**Date:** Tue, 24 Jan 2006 10:19:12 -0800 (PST)  
**From:** "Jaime Saez" <saez\_pdc@yahoo.com> [View Contact Details](#) [Add Mobile Alert](#)  
**Subject:** Canyon River Ranch - Existing well and DOH response  
**To:** "Richard Leider" <rleider@trinityre.com>  
**CC:** "Anthony Robins" <anthonyrobins@msn.com>

Re: Canyon River Ranch Plan Review  
HLA Project No. 06076

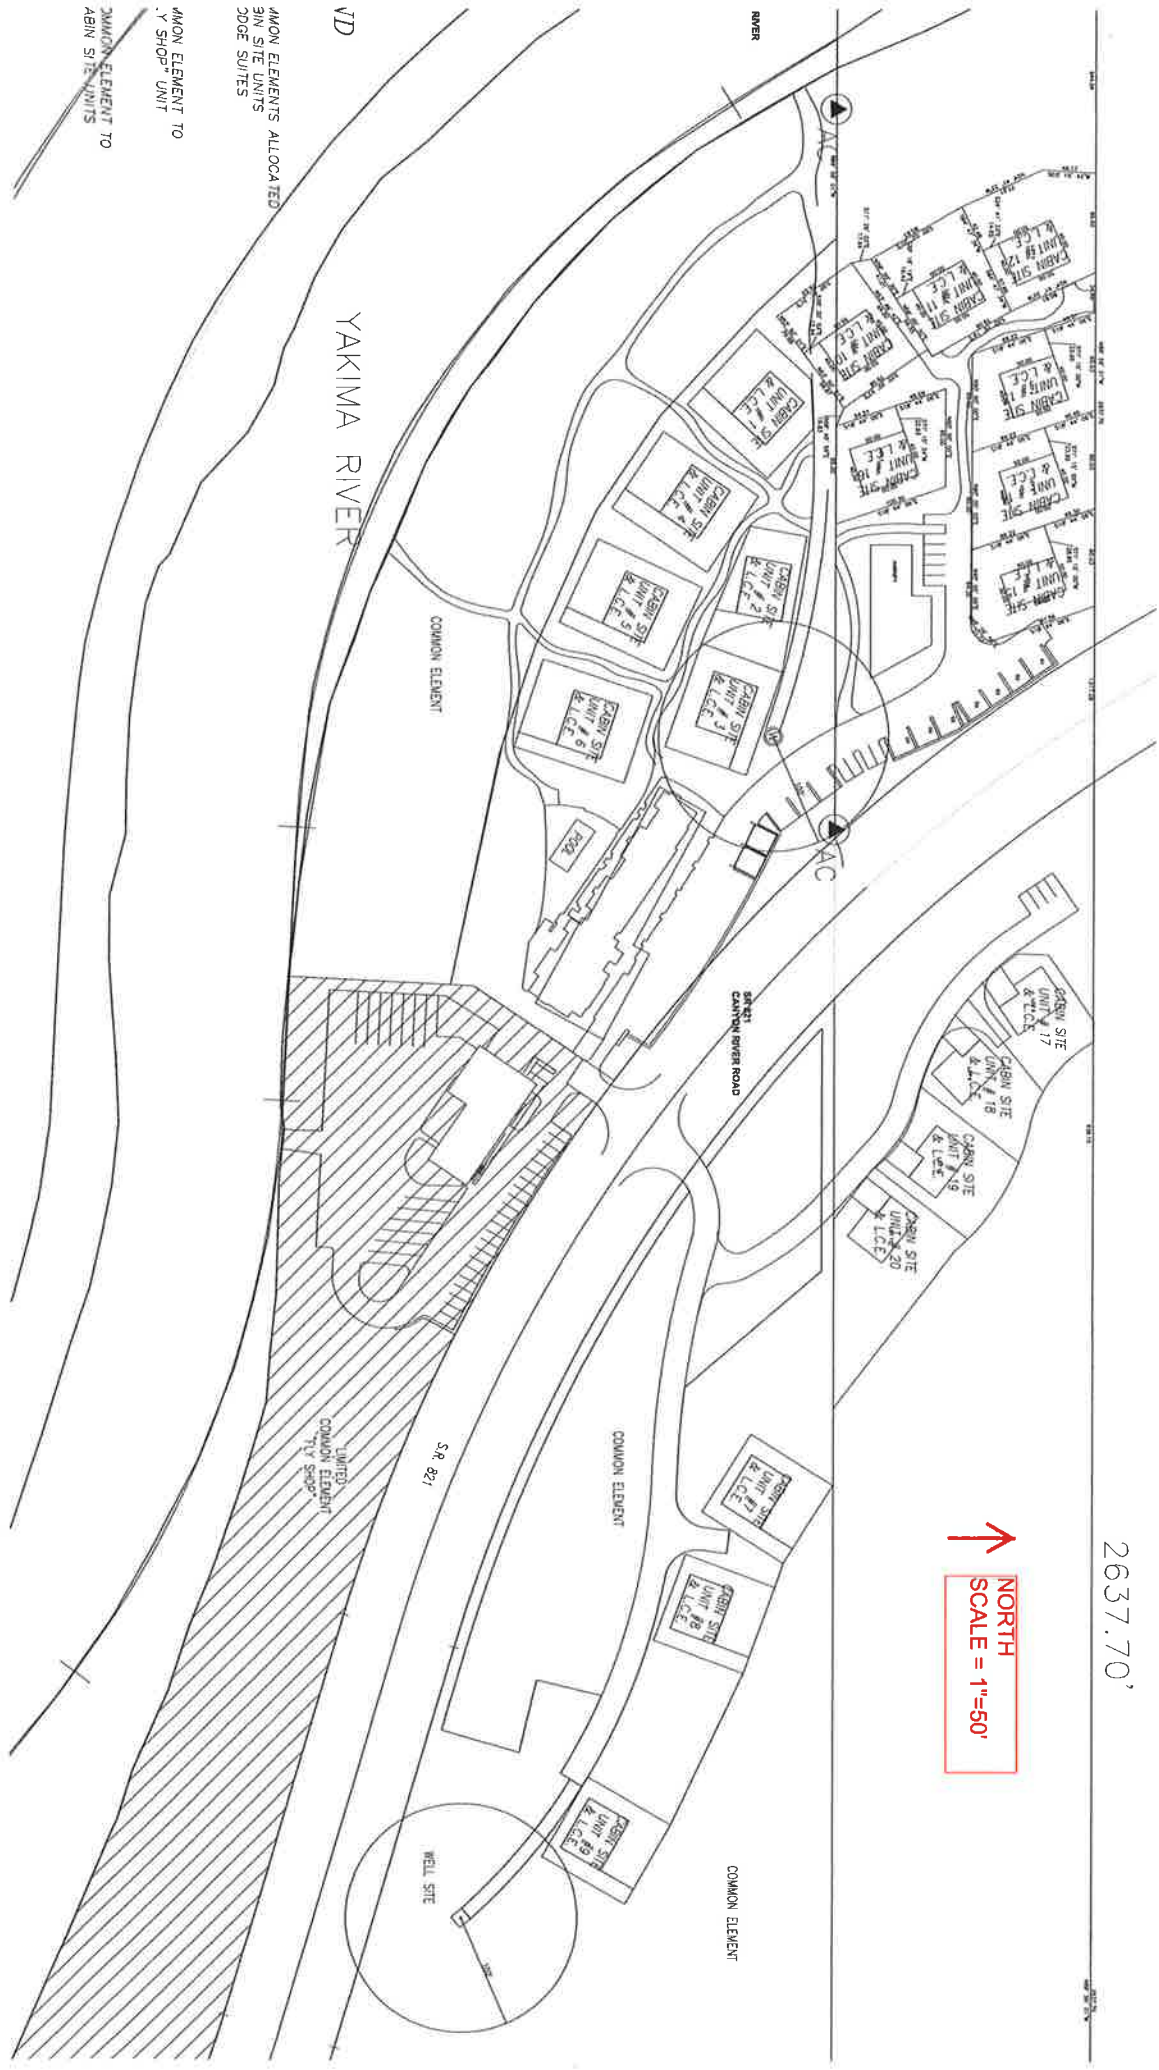
Please confirm or edit the items below regarding the well setbacks discussion we just had:

1. For the 50' setback to adjacent property line: A restrictive covenant agreement will be required by the adjacent property to uphold the remaining setback.
2. Double wall septic lines are ok within the 100' foot well setback zone.
3. Building structures are ok with the 100 foot well set back as long and no fuel or chemical storage, or any other type of contaminant.
4. For any infringements into the 100 foot set back it is recommended it occur within the outer 50 feet.
5. Roadway access to cabins seemed ok within setback.

6. There has been an issue with this well in the past.
7. A description of the well for approval will be required that includes: well depth, diameter, etc... There may be a well tag no. on the well based of record photo at DOH.

I think the items you have listed are generally what we discussed. I have talked to Holly Duncan at Kittitas County Health and let her know we would be working with you and the owner to utilize the existing well for the proposed project. She seemed alright with this. Let me know if you need anything more.
